1	1/13/77	AS BUILT		
2	1/13/77	AS BUILT		
NO	DATE	REVISION	APPR.	
SUBMITTED <i>Norman E. Mitchell</i>				
APPROVED <i>Robert C. Pinner</i> CHIEF - DIVISION OF MINE DRAINAGE REHABILITATION				
APPROVED <i>[Signature]</i> DIRECTOR - BUREAU OF CONSULTING SERVICES				
COMMONWEALTH OF PENNSYLVANIA DEPARTMENT OF ENVIRONMENTAL RESOURCES OFFICE OF ENGINEERING AND CONSTRUCTION PROJECT NO. SL-126-2-7 MINE DRAINAGE POLLUTION ABATEMENT SWATARA CREEK WATERSHED SCHUYLKILL COUNTY BERGER ASSOCIATES, INC. Consulting Engineers P.O. Box 1943 Harrisburg, Penna.				
MIDDLE CREEK CHANNEL LINING				
DRAWN BY W. G.	DATE APR. 17, 1973	DRAWING NO.		16 of 43
CHECKED BY M. W.	SCALE 1" = 50'

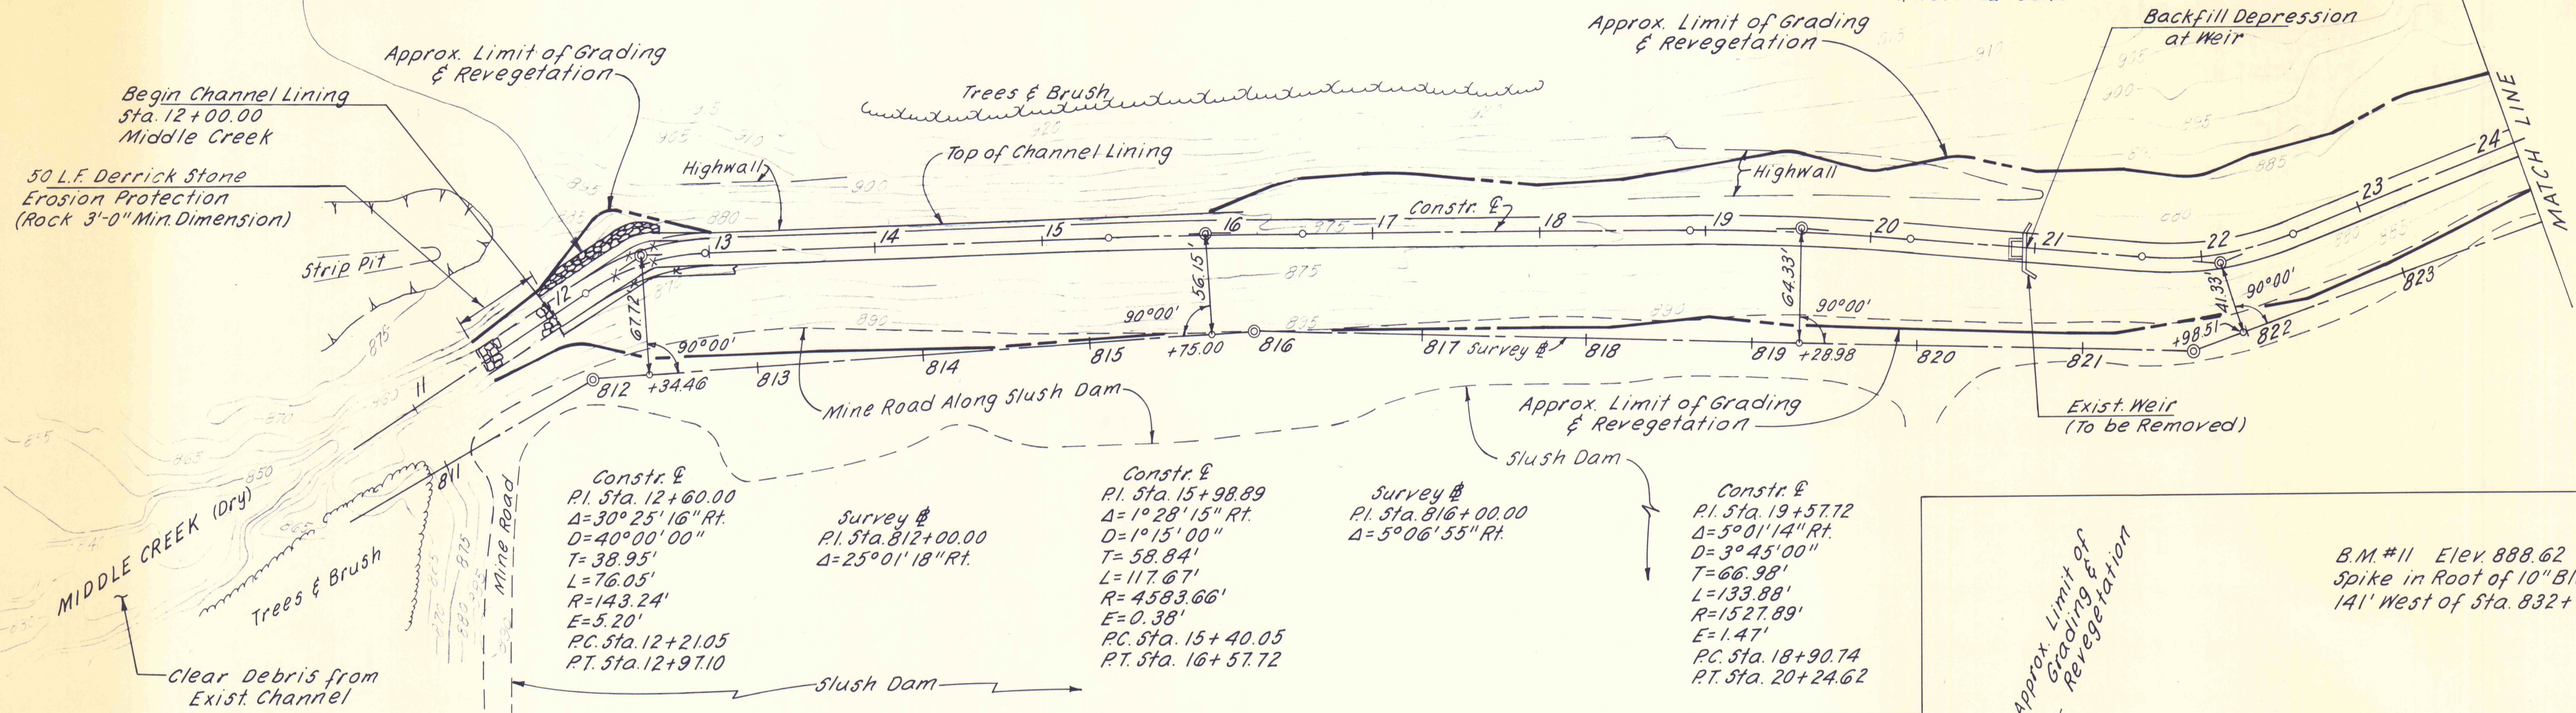
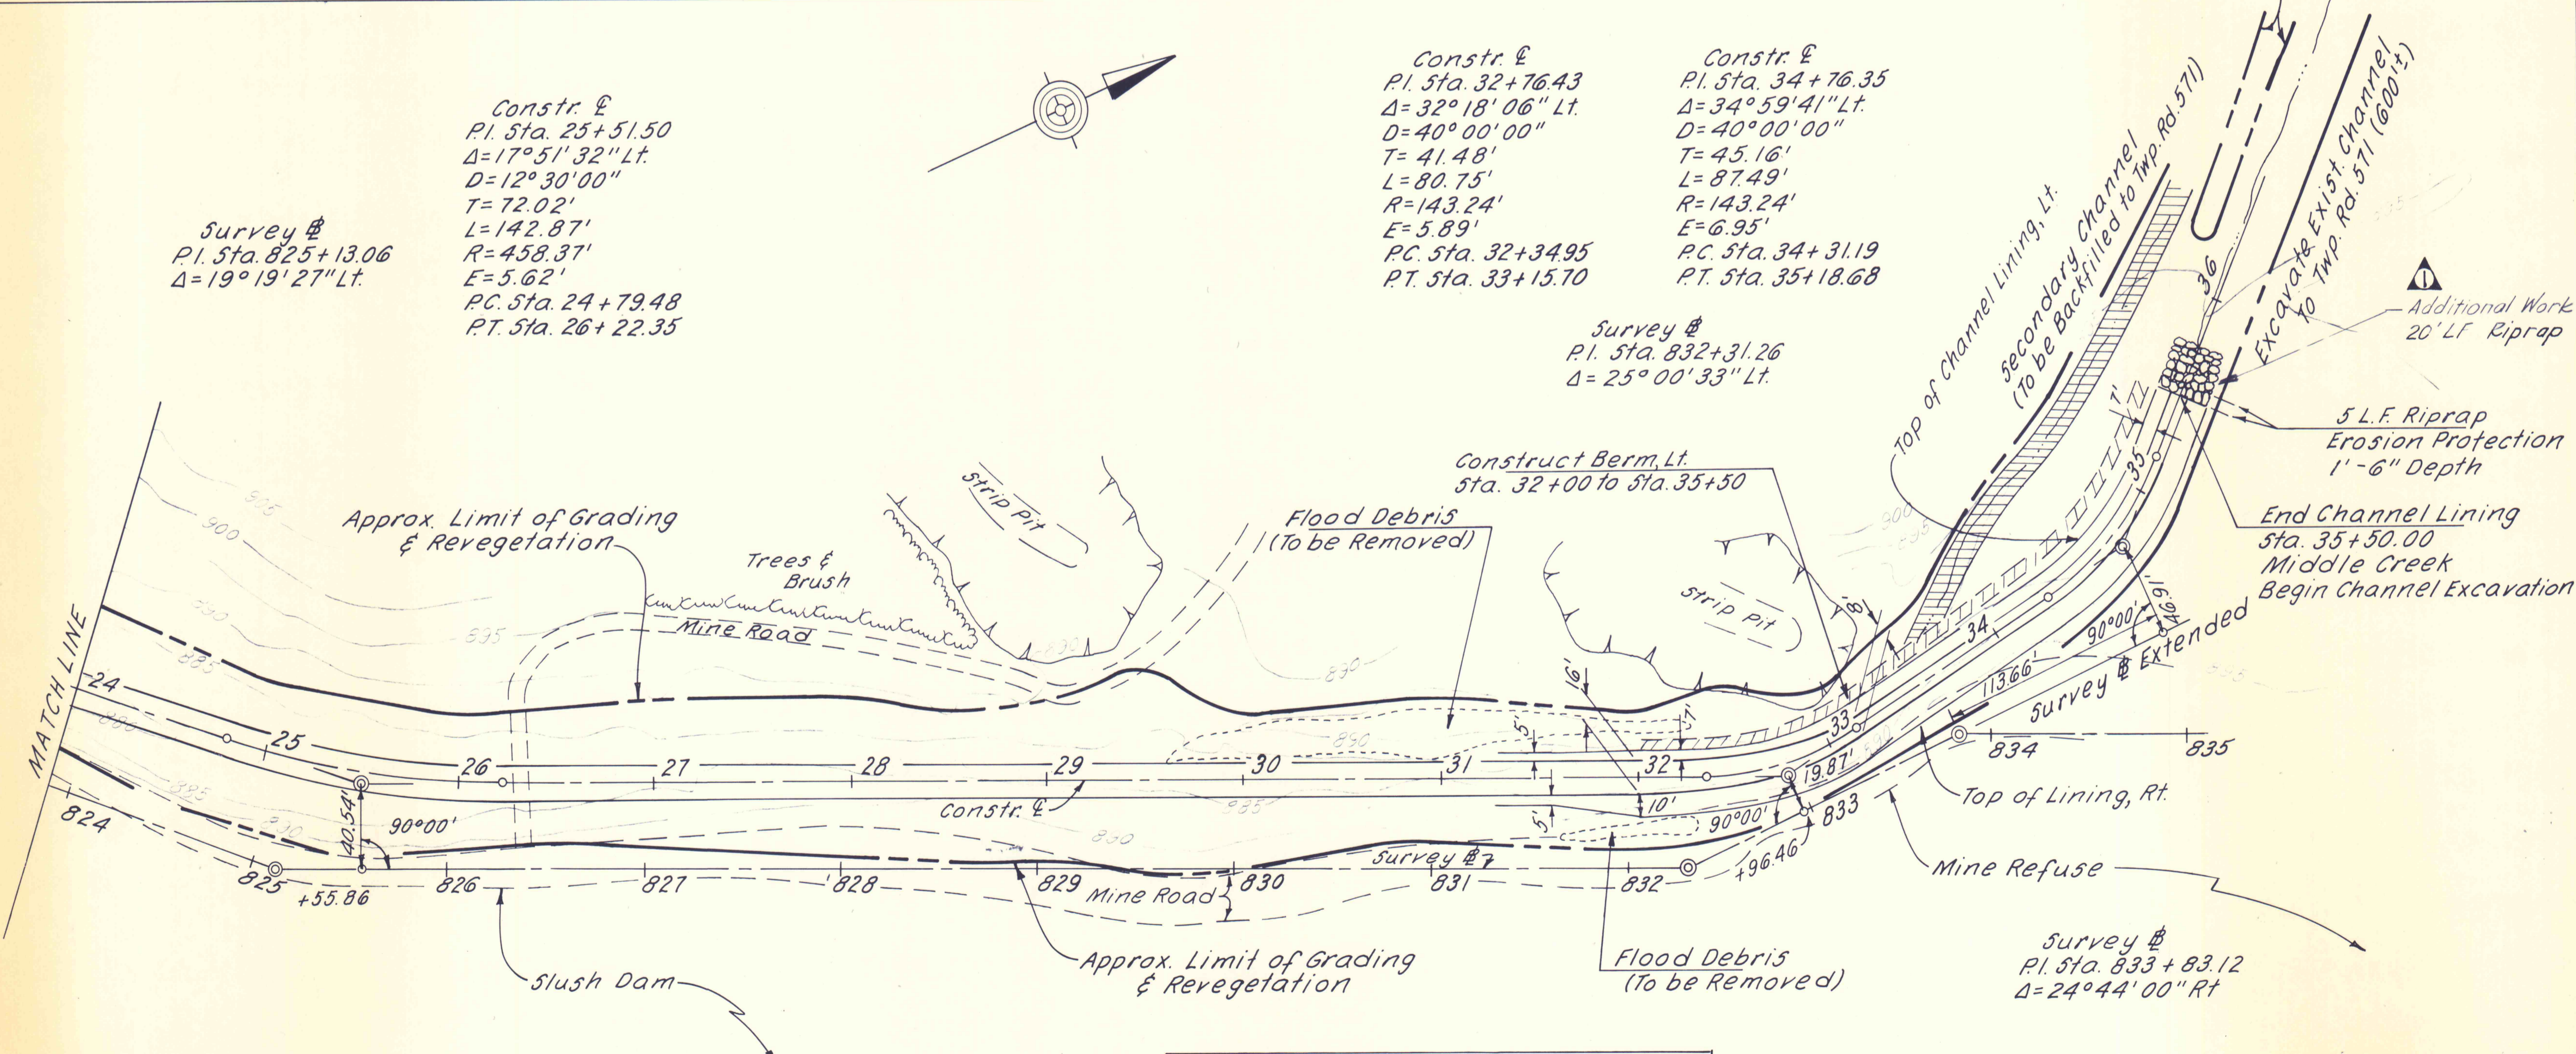
Additional Work due to
Channel Alignment Change:
95 S.Y. Mortared Stone Slope Protection
See Detail A, Drawing 17 of 43. (N.C.)
